**Doc 9710, VAP/13**

INTERNATIONAL CIVIL  
AVIATION ORGANIZATION

## **VISUAL AIDS PANEL**

## **REPORT**

# APPENDIX 6. LOCATION OF LIGHTS ON OBSTACLES

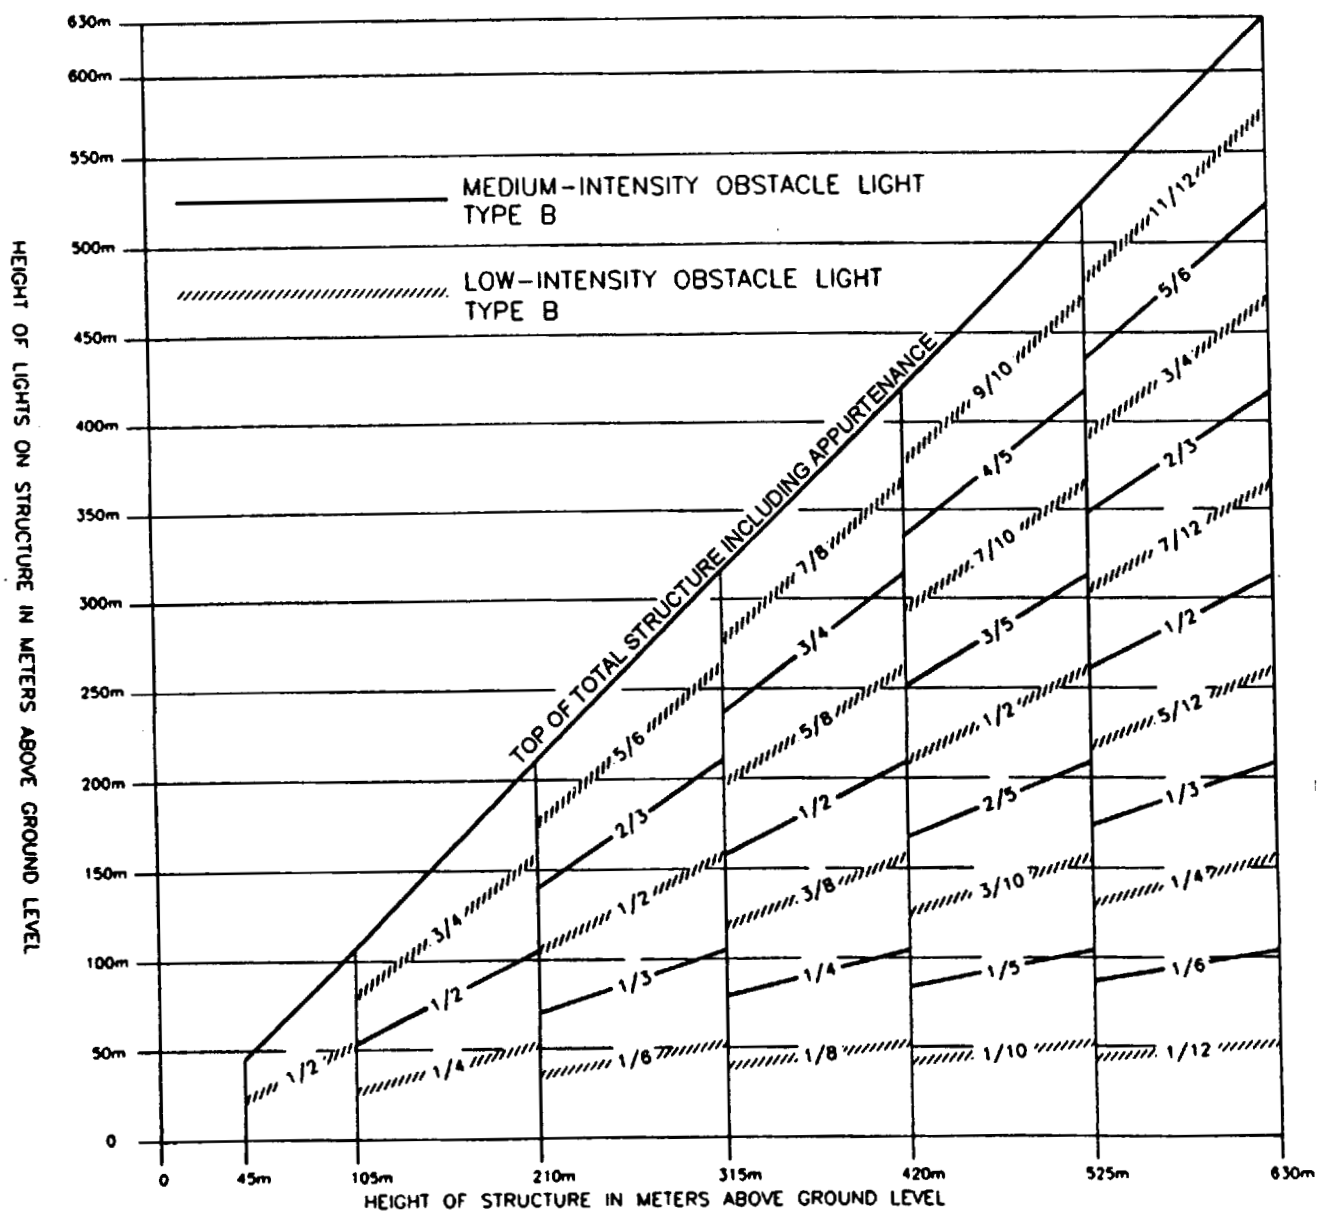
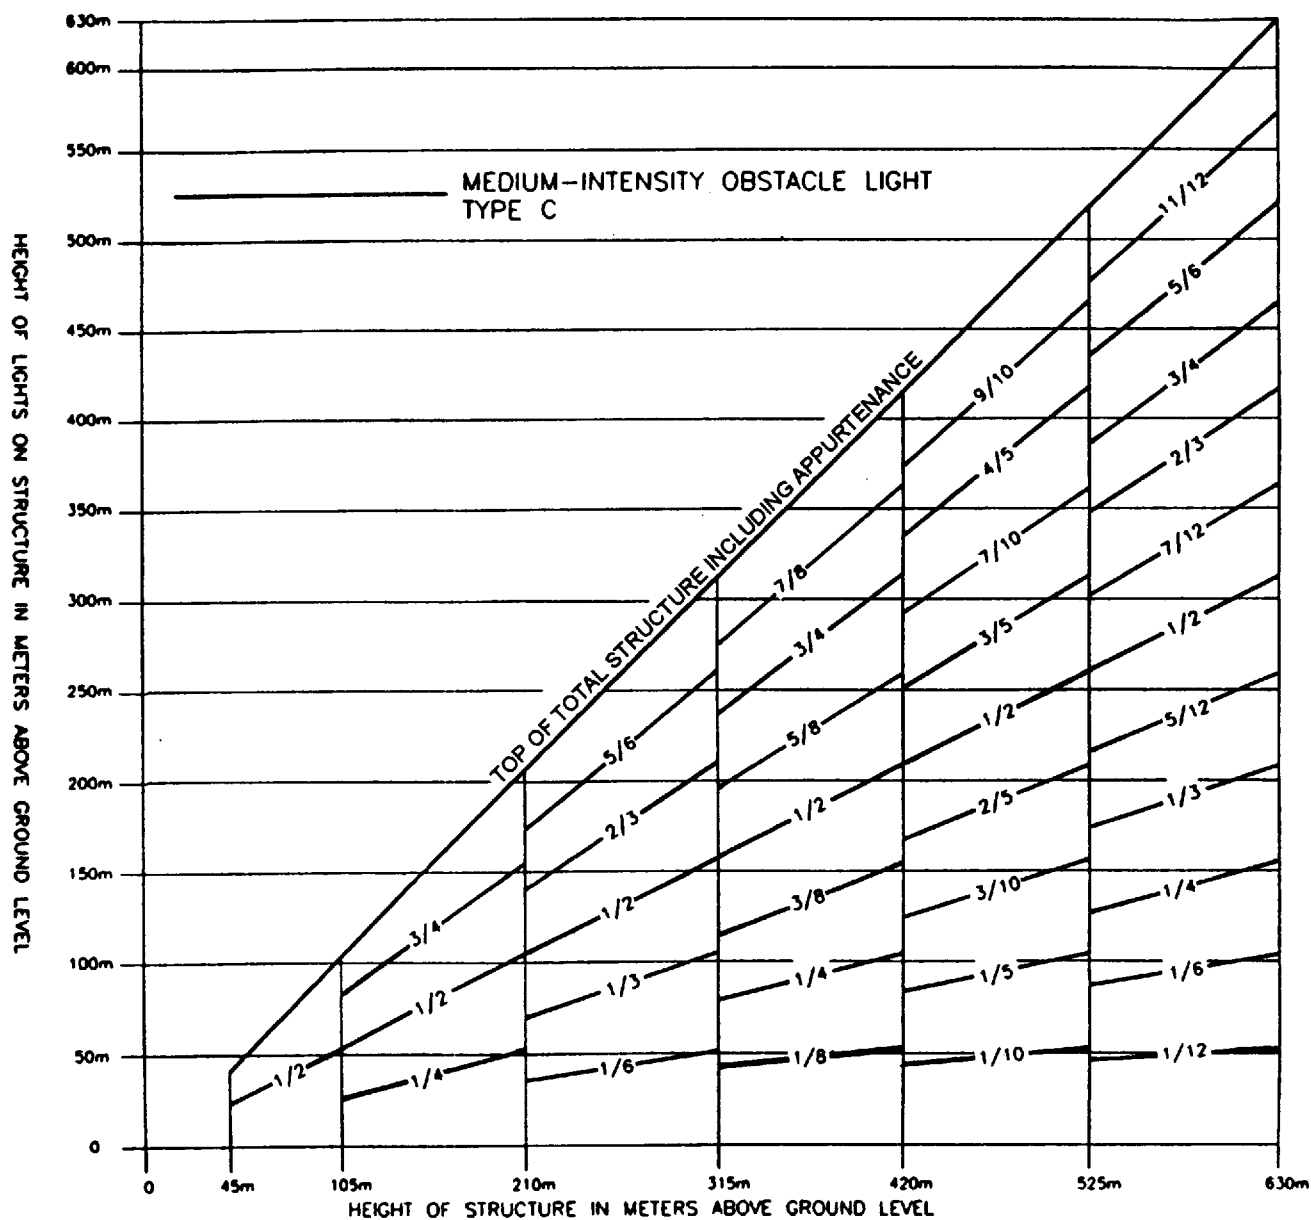
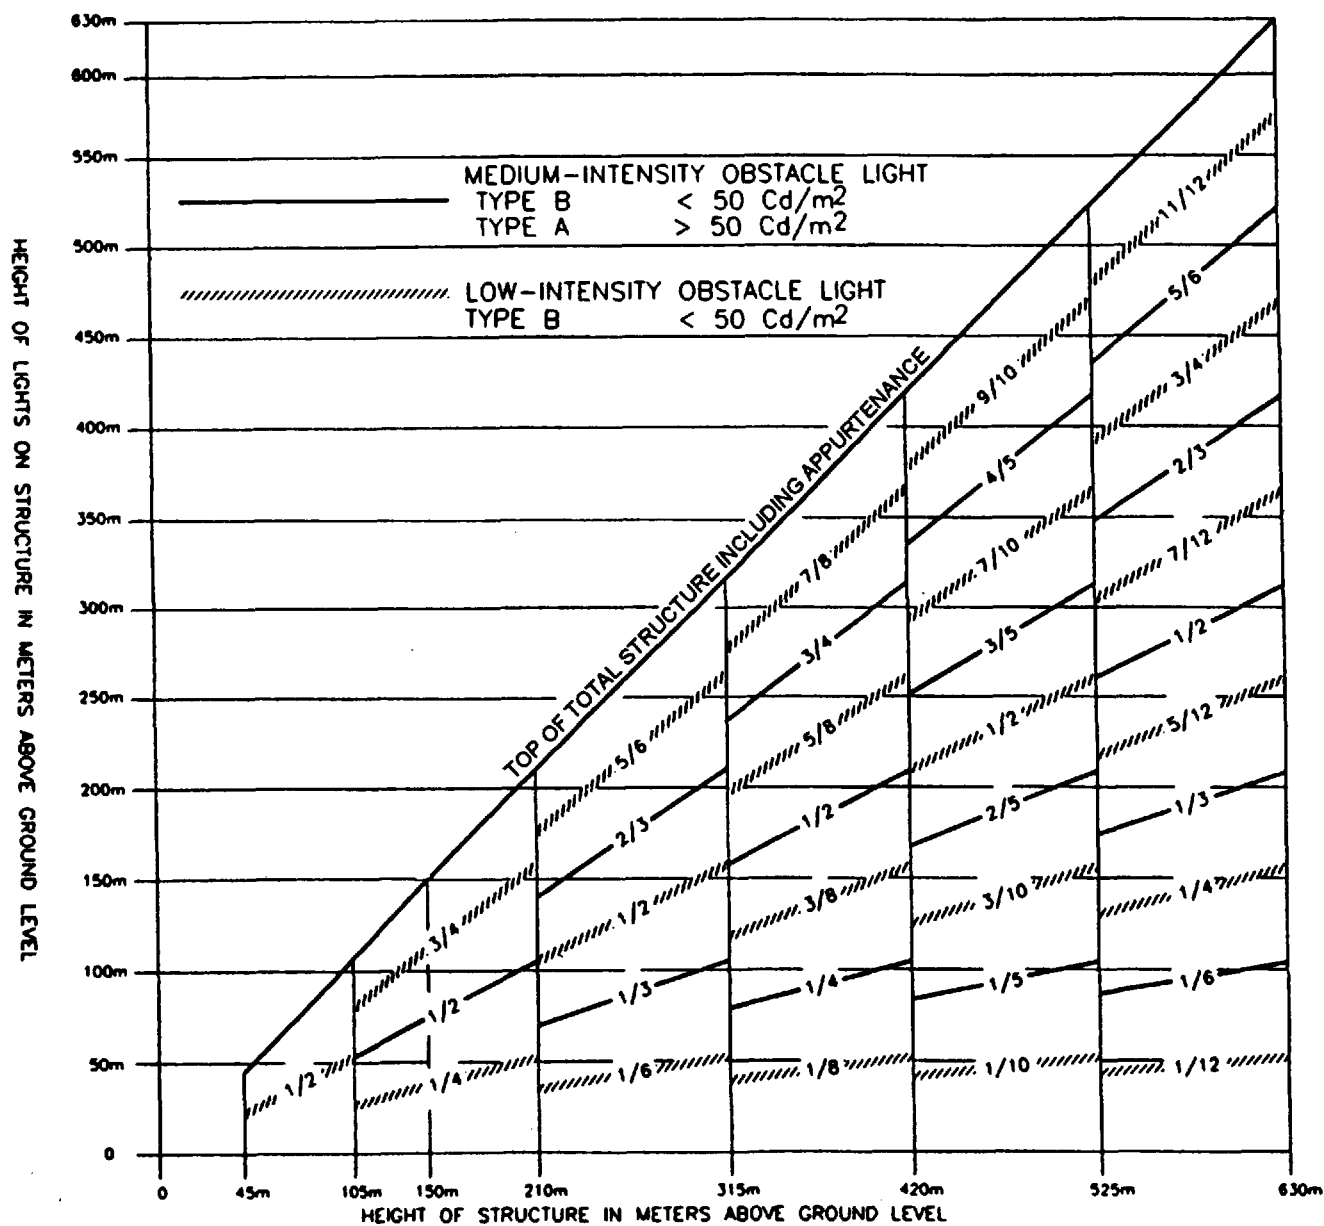
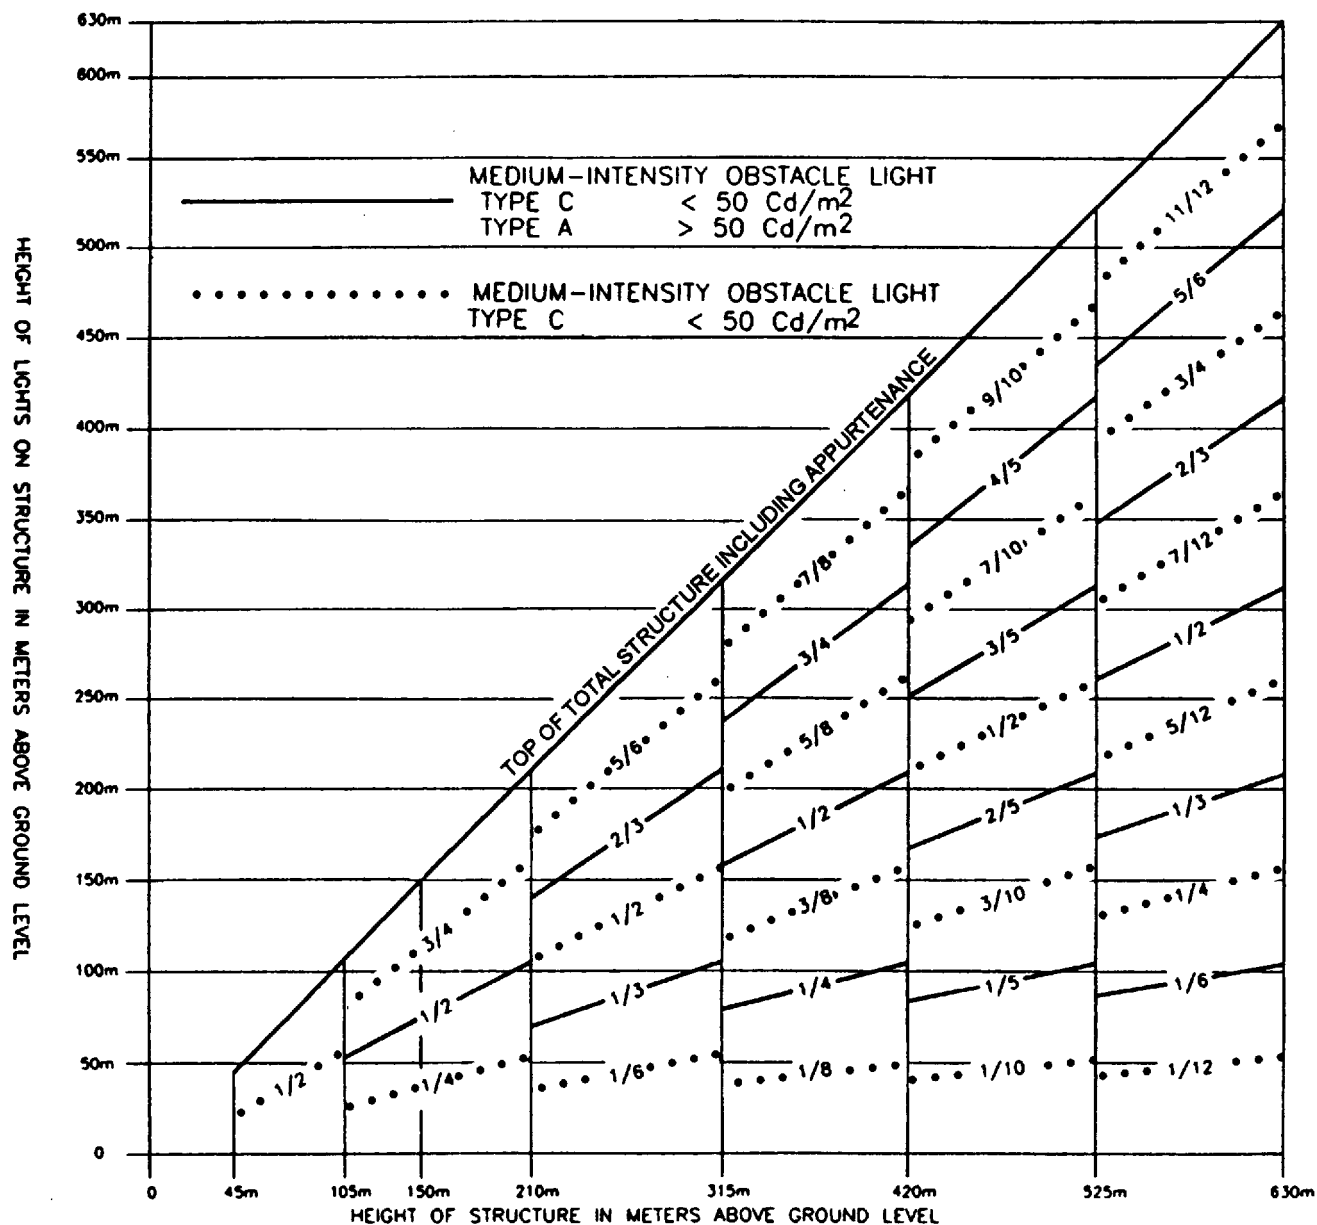
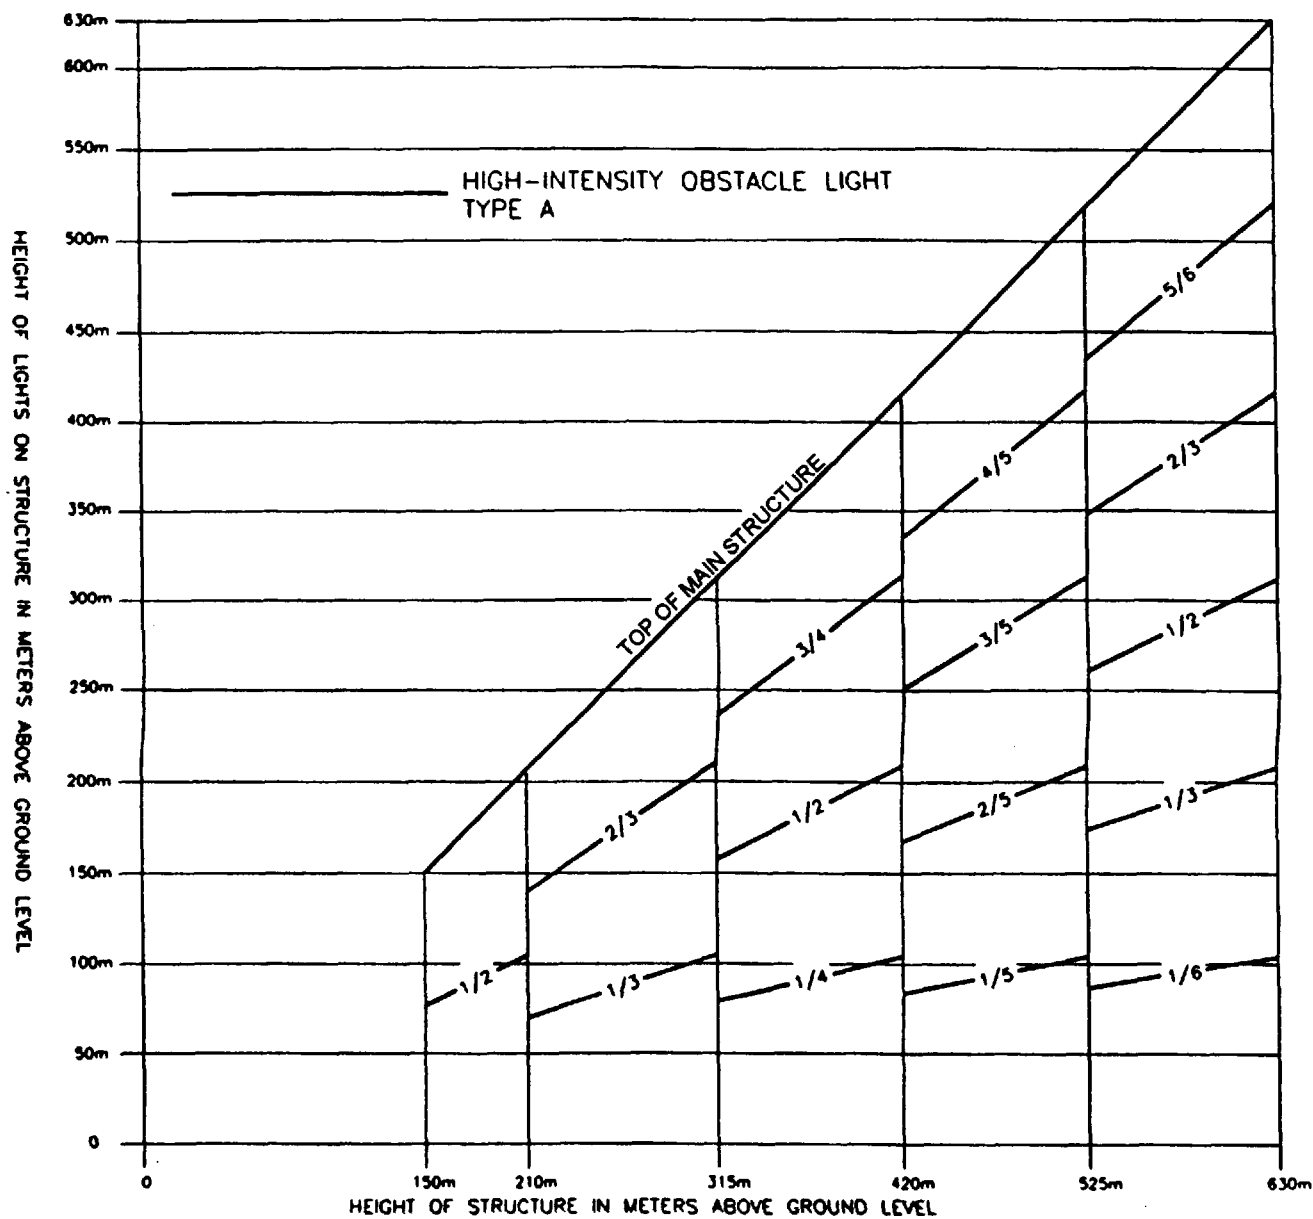
Insert new Appendix 6 as follows:

Note.- High-intensity obstacle lighting is recommended on structures more than 150 m AGL. If medium-intensity lighting is used, marking will also be required.
